HDVS® Display

Subject: **HORIZONTAL CONVERGENCE NOISE**

Model: **HDM-2830/3830**

Figure 1

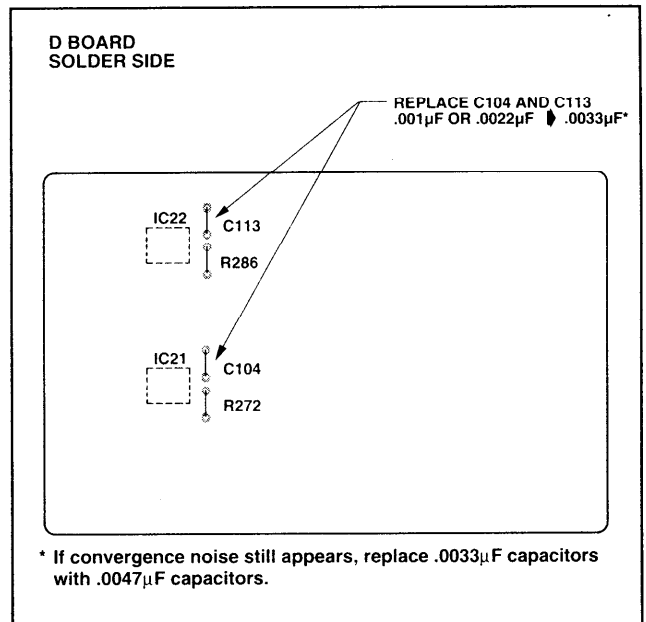
Convergence noise (yellow and/or cyan horizontal lines) may appear in the center of the screen. If this occurs, replace C104 and C113 (.001 μ F or .0022 μ F) on the D board (solder side) with new .0033 μ F capacitors. (See Figure 1.)

NOTE: If convergence noise still appears, replace new .0033 μ F capacitors with new .0047 μ F capacitors.

Since vertical convergence of all corners will also be affected, readjust both vertical and horizontal convergence after replacement of these capacitors. Refer to the appropriate Operation and Maintenance Manual.
